Slide out bulb seal and schwintek slide out motor

Bulletin Type:	TSB	Publication Date:	May 2023
Bulletin #(s):	23-100	Make(s):	Starcraft
Job Code(s):	9802518	Model(s):	Super Lite TT
Flat Rate(s):	0.50 Hr. Labor – Bulb Seal and Schwintek Motor Repair	Model Year(s):	2023

Bulletin Type:	TSB	Publication Date:	May 2023
Bulletin #(s):	23-106	Make(s):	Highland Ridge
Job Code(s):	9804518	Model(s):	Range Lite
Flat Rate(s):	0.50 Hr. Labor – Bulb Seal and Schwintek Motor Repair	Model Year(s):	2023

Fig. 1

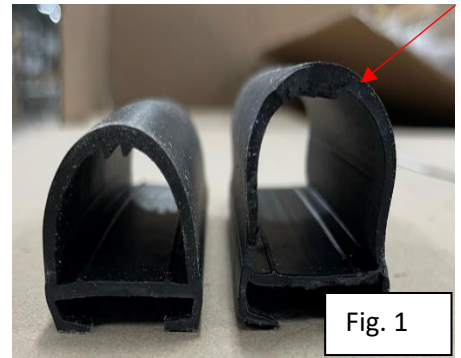
1. Proceed with the installation instruction if the larger bulb seal on the outside slide-out as shown by the red arrow in figure 1 is not present.
